PLANNING UNIT REPORT
DEPARTMENT OF PLANNING AND DEVELOPMENT
May 3, 2006

CONDITIONAL USE APPLICATION:

SUBJECT: **1701 Thierer Road –Conditional Use – Construct New 8000 Sq. Ft. Retail**

PROPOSED FACILITY FOR
EAST POINTE PLAZA
RETAIL
 MADISON, WISCONSIN

CC: Project contact person, John Bieno: jjbien0@tjkdesignbuild.com (email)
Atch. Exhibit page "L1 Landscape Plan" [4/5/2006], notated with approximate amenity location

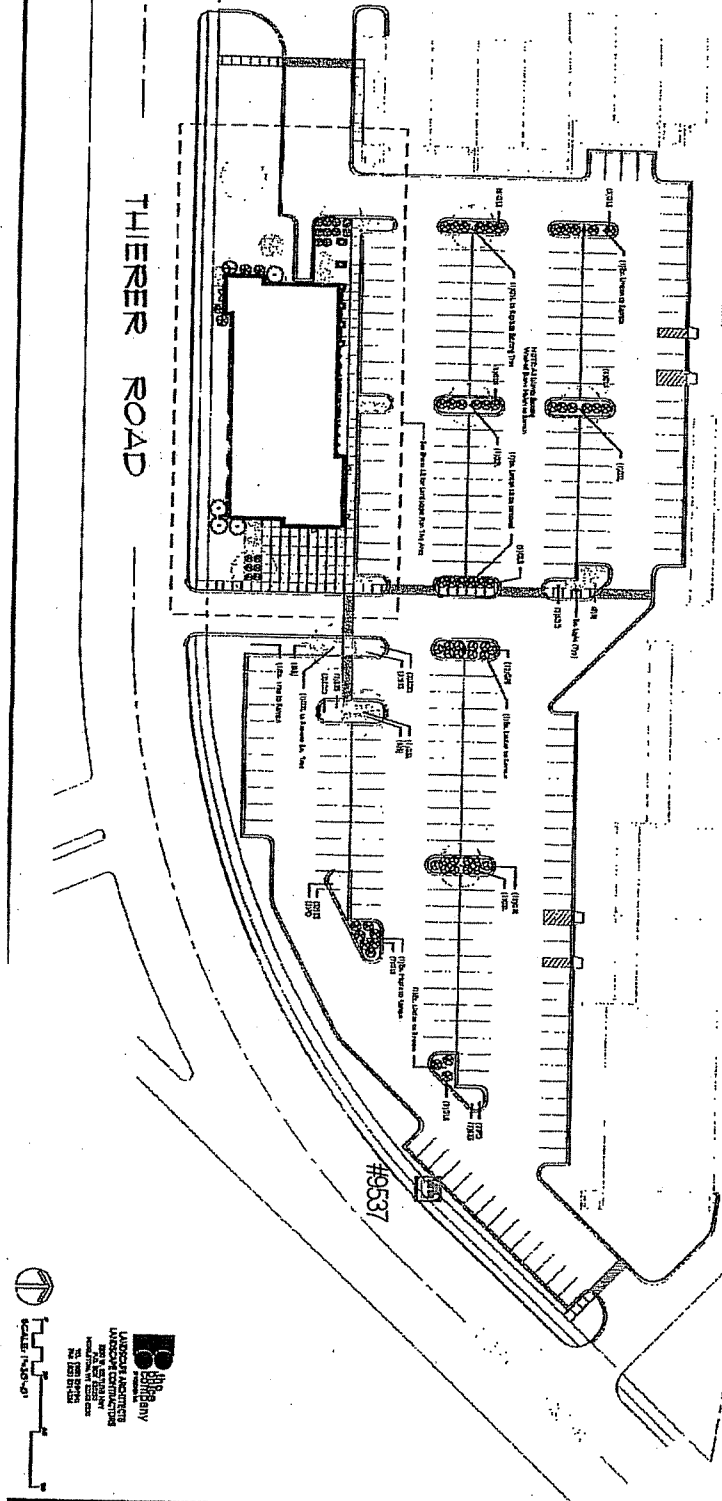
1. The applicant shall install a concrete passenger boarding pad on the north side of Lien Road, approximately eight feet east of bus stop sign pole #9537. This bus stop is located about 180 feet west of the parcel's Lien Road driveway access, and 200 feet east of the Lien Road intersection with Thierer Road. The concrete pad shall occupy the full distance of the terrace, measure 6 feet in width parallel to the street, and lie flush between the sidewalk and the top of curb.
2. The developer shall include the location of these passenger amenities on the final documents filed with their permit application so that Metro Transit may review and approve the design.
